SUBJECT: SEP TOPICS III-6, SEISMIC DESIGN CONSIDERATIONS AND III-11,
COMPONENT INTEGRITY - BIG ROCK POINT NUCLEAR POWER STATION

SYSTEMATIC EVALUATION PROGRAM
Topics III-6 and III-11
Big Rock Point Nuclear Power Plant

TOPICS: III-6, SEISMIC DESIGN CONSIDERATIONS
III-11, COMPONENT INTEGRITY

Figure 1: Reactor Building "stick" model.

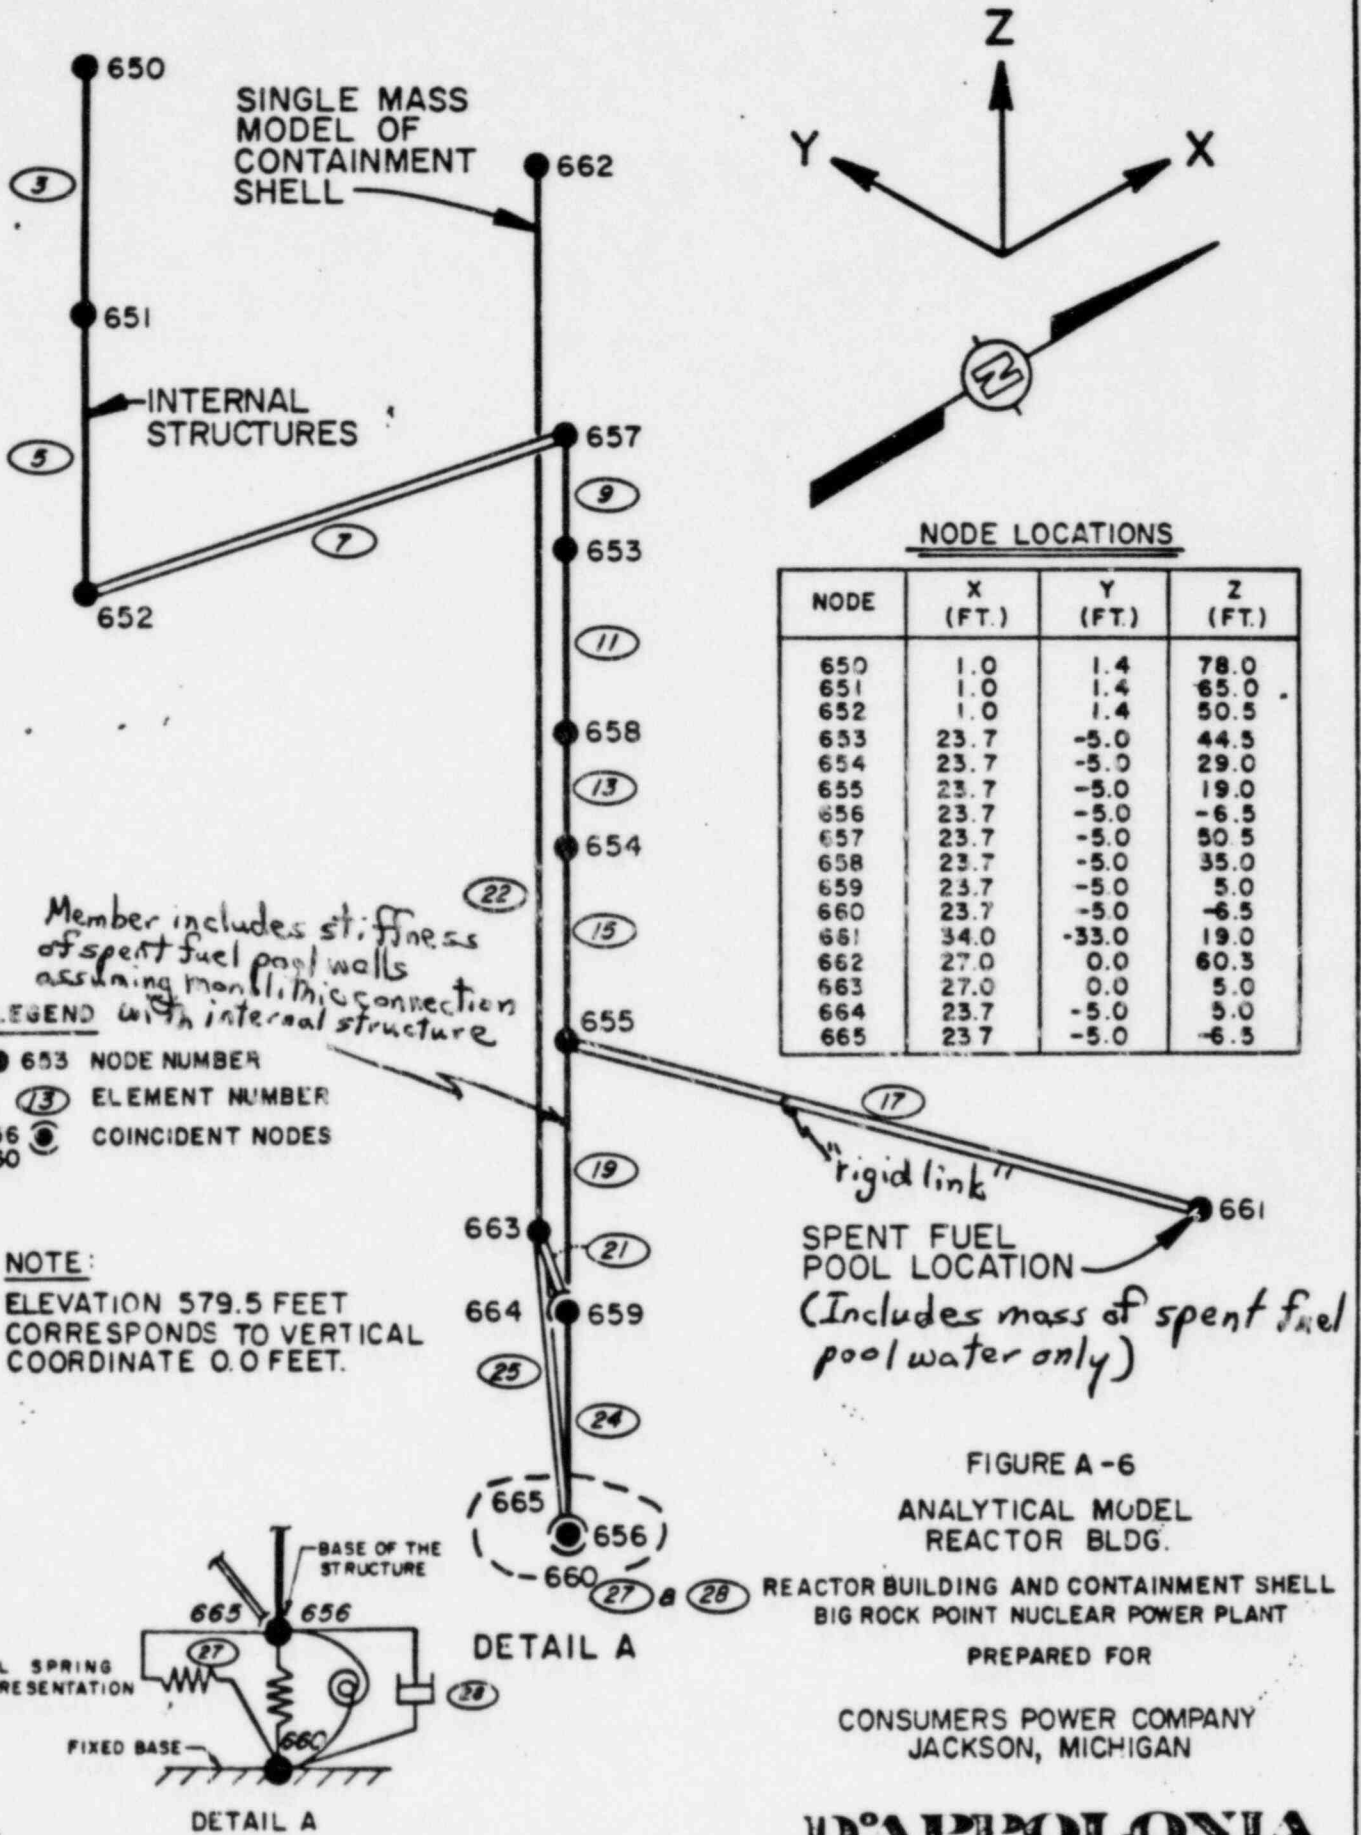
The "stick" model used for the analysis of the Reactor Building concrete structure was derived assuming that the spent fuel pool structure would behave monolithically with the concrete internal structure around the reactor and the steam drum enclosure, as indicated in Figure 1.

Figure 2: General relationship of spent fuel pool with the rest of the Reactor Building.

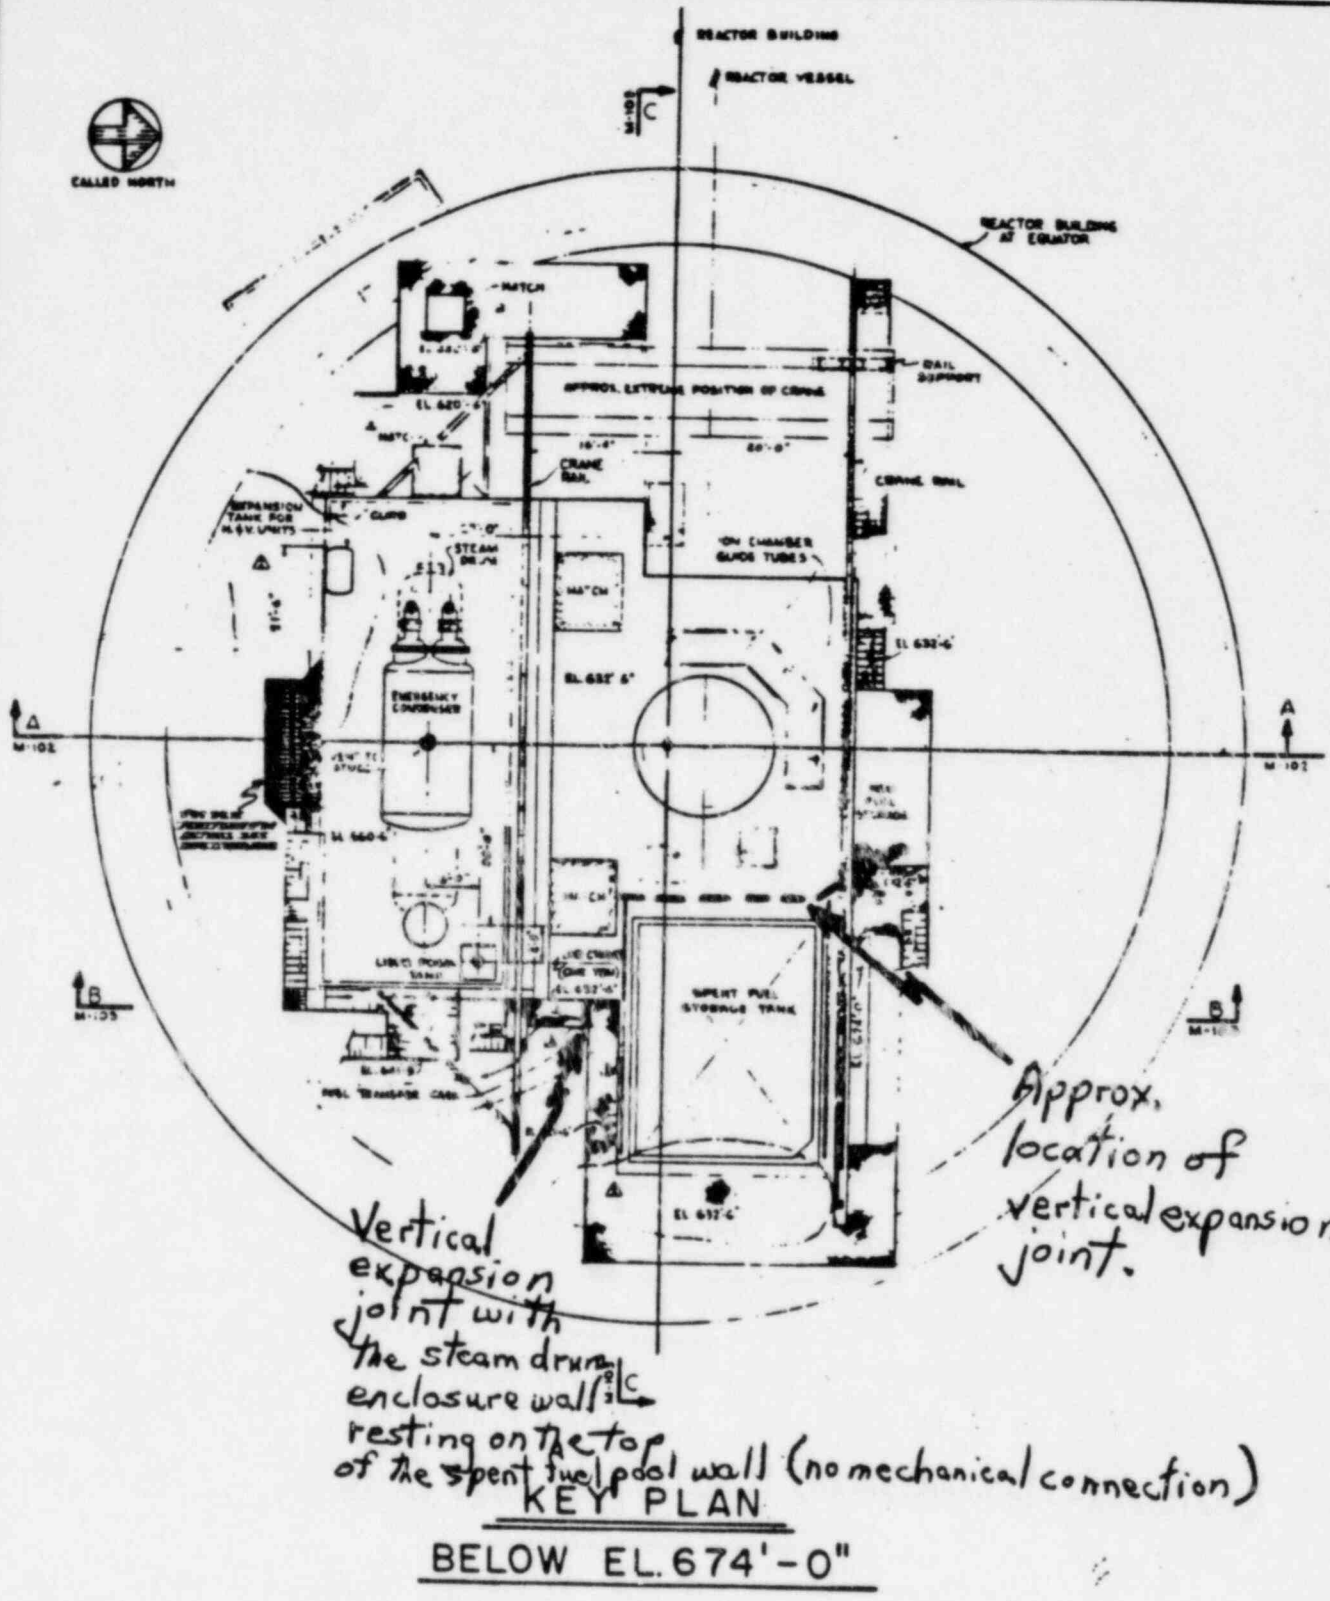
Figure 2 indicates the general arrangement of these items and illustrates the expansion joints between the steam drum and reactor enclosures and the spent fuel pool. These were not evaluated in the initial D'Appolonia Analyses. As indicated in Figures 3 through 5, these details were clearly illustrated on at least 4 of the construction drawings. Figure 3 illustrates that the only connection between the steam drum enclosure and spent fuel pool structure is a vertically acting bearing connection between the steam drum enclosure wall near the top of the spent fuel pool south wall and a thin slab connection at the floor of the spent fuel pool. Figure 4 illustrates that the only connection between the reactor enclosure wall and the east spent fuel pool wall is through a predominantly vertical acting shear key. By inspection, the behavior assumed in the Reactor Building model is at least questionable. In addition, such detailing is not unreasonable for a facility which was initially designed with minimal lateral load consideration. In response to

Figure 7: Big Rock Point concrete ventilation stack details.

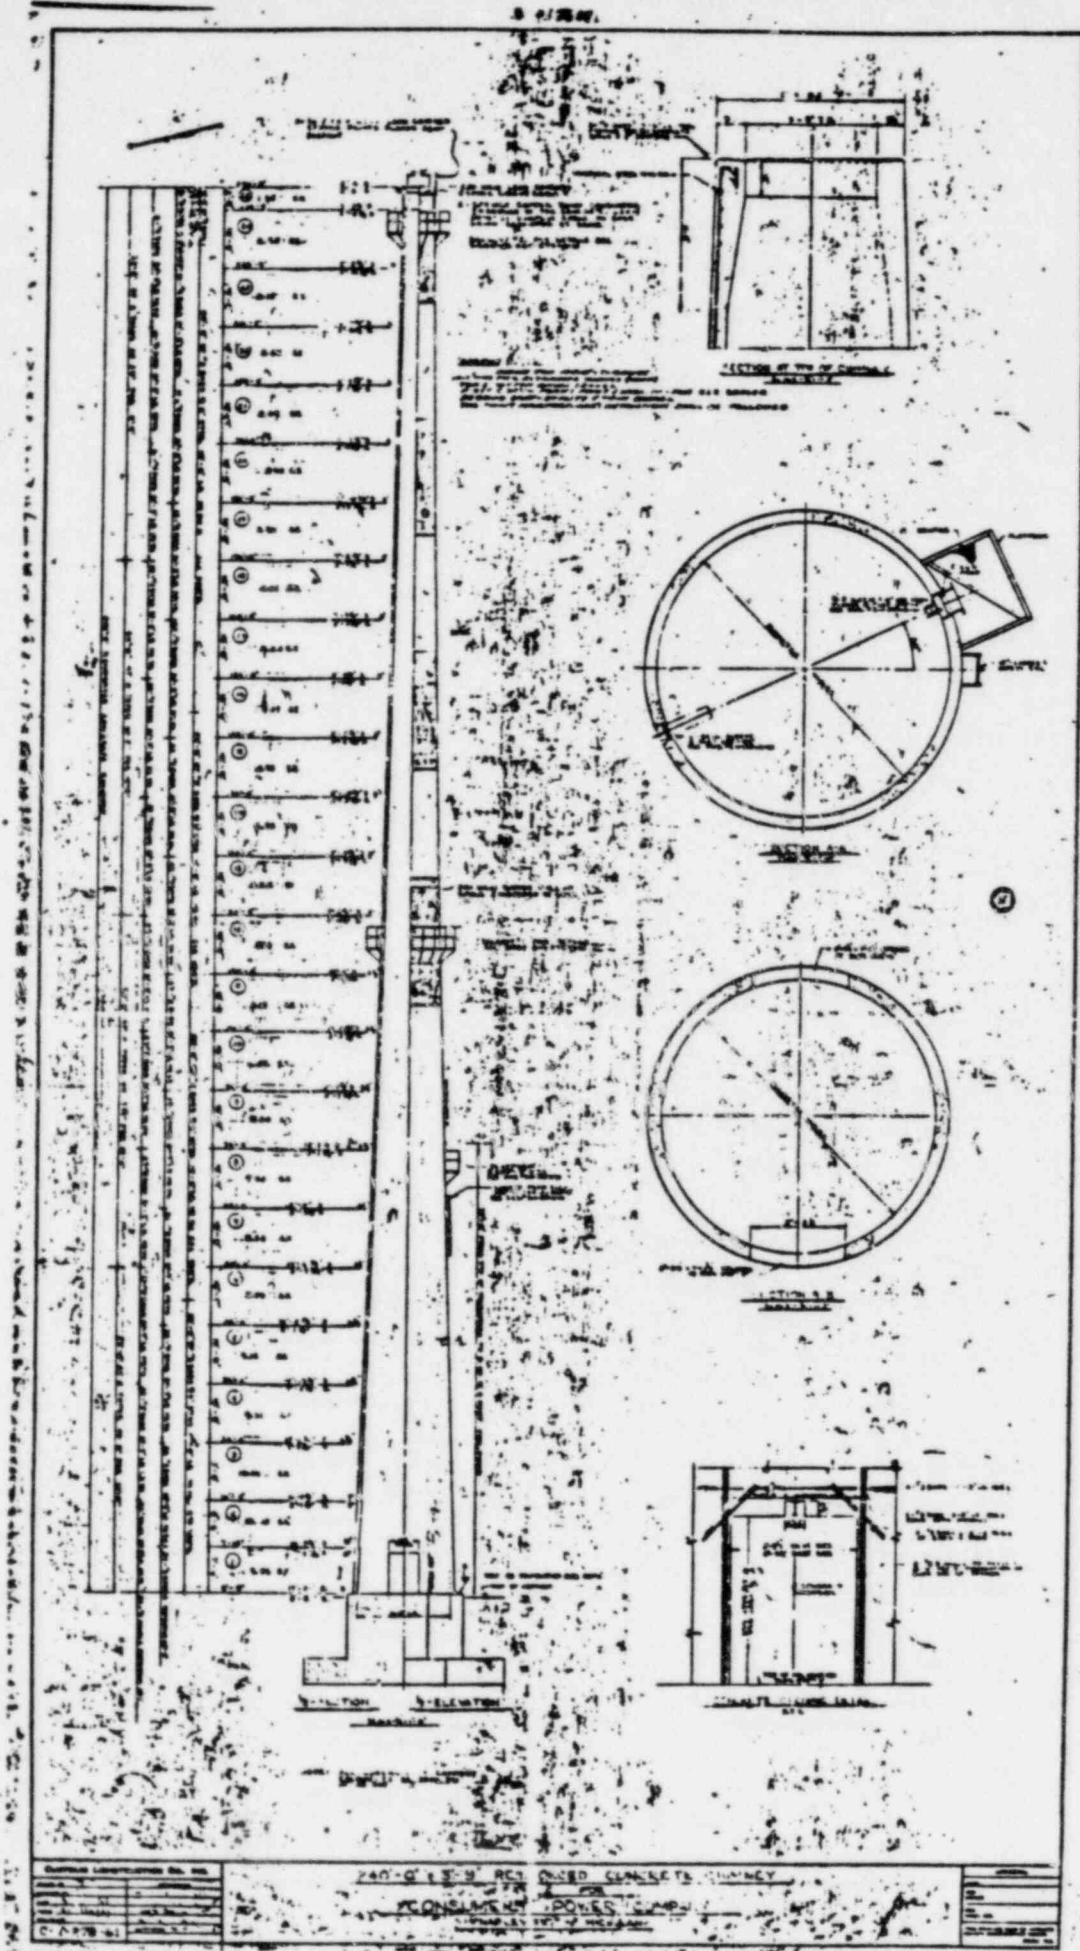
Thermal stress contributions are not given for the seismic load combination. Figure 7 shows the vertical steel to be located outside the circumferential steel. Given that the stack varies in thickness between 6" and 8", the vertical steel should not be located any further from the outside surface than one-half the thickness, and is probably closer to the outside face. Per equation 16 on page E1-8 of the August 1981 D'Appolonia report Volume IV, the vertical steel stress due to thermal should be computed based upon:
